Findings

Evaluation of Storm Surge in Areas Outside the Greater New Orleans Hurricane and Storm Damage Risk Reduction System (HSDRRS)

Thomas Nolan Thompson
March 11, 2019

Objective:

Figure 15 Storm Surge Development for Hurricane Betsy on the SL15-1965 Grid.

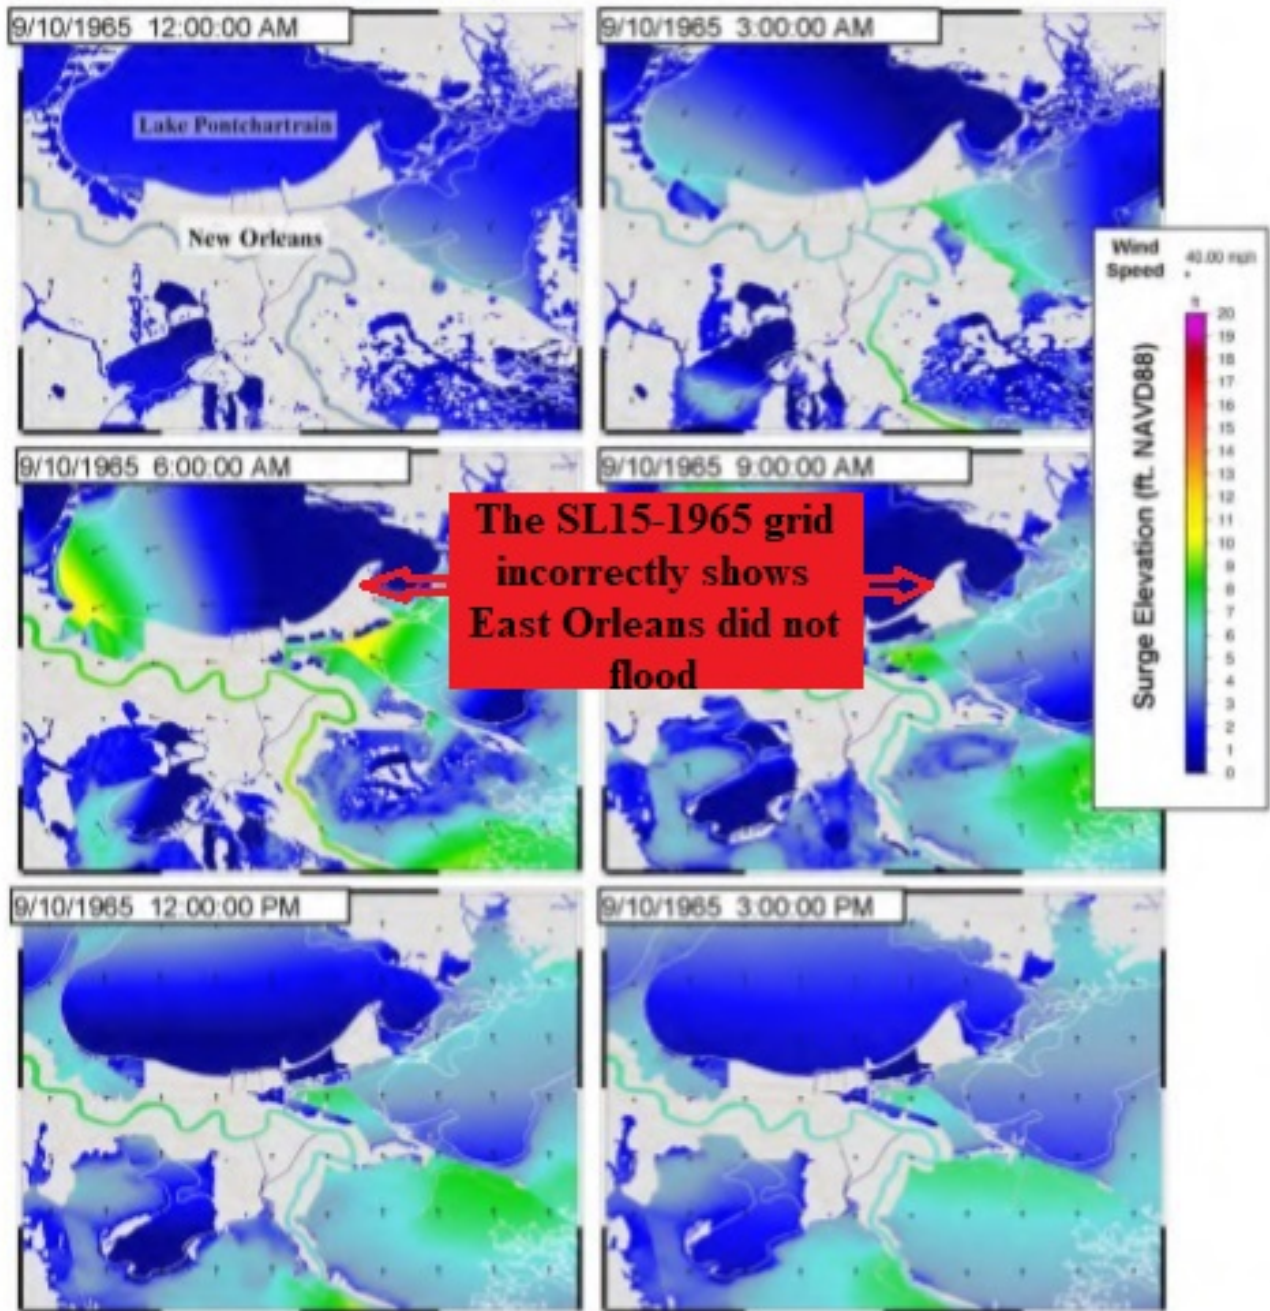
Document 1 - The SL15-1965 grid used in the Corps' HSDRRS evaluation of storm surge impact shows high levees along the Lake Pontchartrain shoreline that were either significantly lower or did not exist in 1965 (Page 18, Figure 10).

The Corps used drawings from a 1987 General Design Memorandum of the South Point to the Gulf Intracoastal Waterway levee and the levee along the Inner Harbor Navigation Canal to extract and "estimate" the approximate levee elevations used in their SL15-1965 baseline (See grid assumptions and levee elevation extractions on page 13, paragraph 4 through page 14 paragraph 4 and Figure 10 on Page 18). "Actual" topographic elevations are given in the 1965 Corps' Hurricane Betsy Report and the 1965 Army's Lake Pontchartrain and Vicinity Report.

In addition, the levees used to establish the SL15-1965 baseline are located on the extreme eastern and southern edges of New Orleans East, but their estimated elevations were extracted to "assume" the existence of a levee along the northern edge of New Orleans East lake shoreline that 1965 Corps documents state "will require" a 6.3 mile long levee, with an elevation of 10 feet.

Because the Corps modeled a non-existent levee, with an assumed elevation of approximately 14 feet, thousands of acres of floodplain that did exist in 1965, were omitted from their SL15-1965 grid. This discrepancy has a significant impact on the validity of the SL15-1965 grid model. Reference: Figure 15 on Page 24.

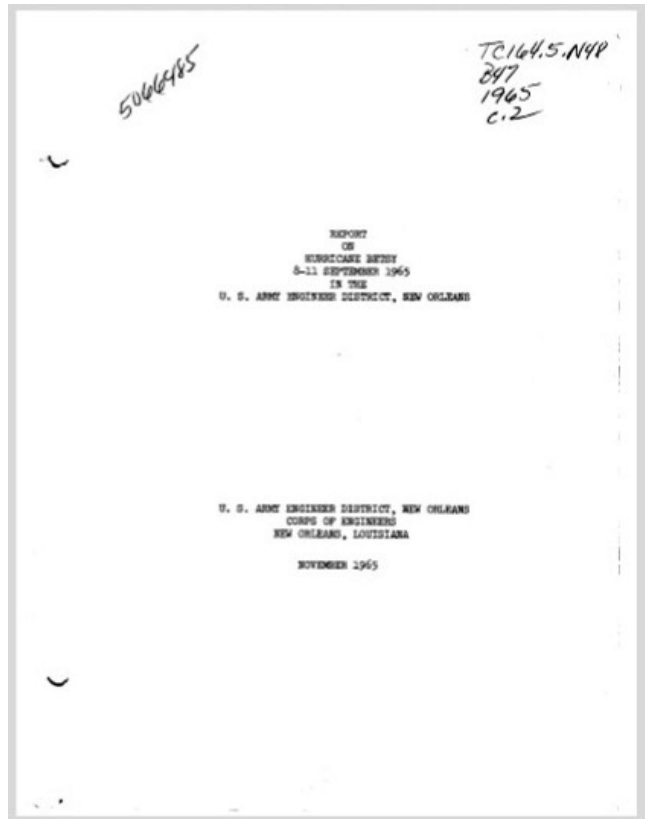
Document 2 - The 1965 Corps' Hurricane Betsy Impact Report identified existing 1965 levees and structures and shows storm surge inundation locations which conflicts with the SL15-1965 grid used in the Corps' HSDRRS Evaluation of Storm Surge Impact report's Figure 15.

The 1965 Corps' Hurricane Betsy Impact Report Plate 5 on page 82 shows no levees along the northern edge of New Orleans East lake shoreline and storm surge inundating thousands of acres of flood plan that existed in 1965. This discrepancy has a significant impact on the validity of the SL15-1965 grid model.

Existing 1965 levees documented in The Secretary of the Army's letter on Page 88 Plate 1

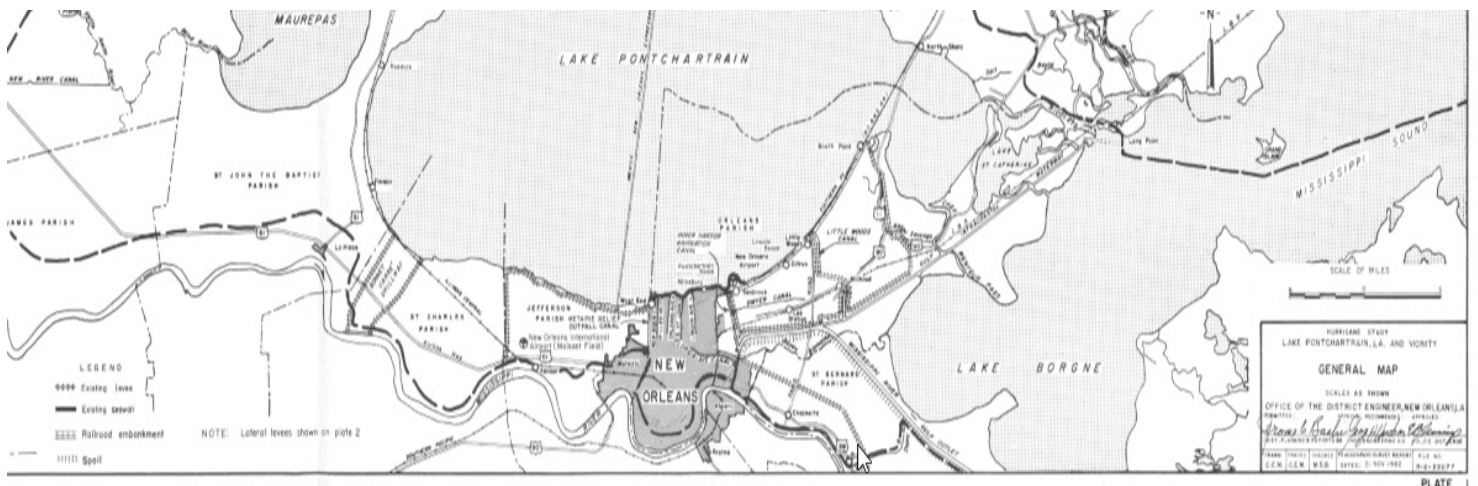
Document 3 - The Secretary of the Army documented the status of existing levees and topographic features in their 1965 Lake Pontchartrain and Vicinity document. The finding in the Secretary of the Army document conflicts with the SL15-1965 grid used in the Corps' HSDRRS Evaluation of Storm Surge Impact report.

The 1965 Secretary of the Army's letter states that the only 1965 surge protection between Jefferson Parish and the Inner Harbor Navigation Canal was a step-face concrete seawall along the lakefront and levees along its east and west boundaries listed on page 27, paragraph 1 of the letter.

The 1965 Secretary of the Army's letter states that the only 1965 surge protection in the Inner Harbor Navigation Canal area was a canal spoil bank about 5 feet high listed on page 27, paragraph 2 of the letter.

The 1965 Secretary of the Army's letter listed New Orleans East protection in paragraph 4 on pages 33 and 34, as follows: a 2.3 mile seawall at the New Orleans Airport with an average elevation of 11 ½ feet; a severely damaged 11 ½ mile Southern Railway embankment about 9.3 feet high that "Will Not" provide protection against hurricane tides and waves; west protection consisted of the Inner Harbor Navigation Canal having a grade of 9.6 feet; east protection consisted of a levee extending from South Point to the Gulf Intracoastal Waterway with an elevation of 11.6 feet; south protection consisted of a levee along the Gulf Intracoastal Waterway with an elevation of 9.6 to 14 feet. No other levees or surge protection is referenced along the Lake Pontchartrain shoreline.
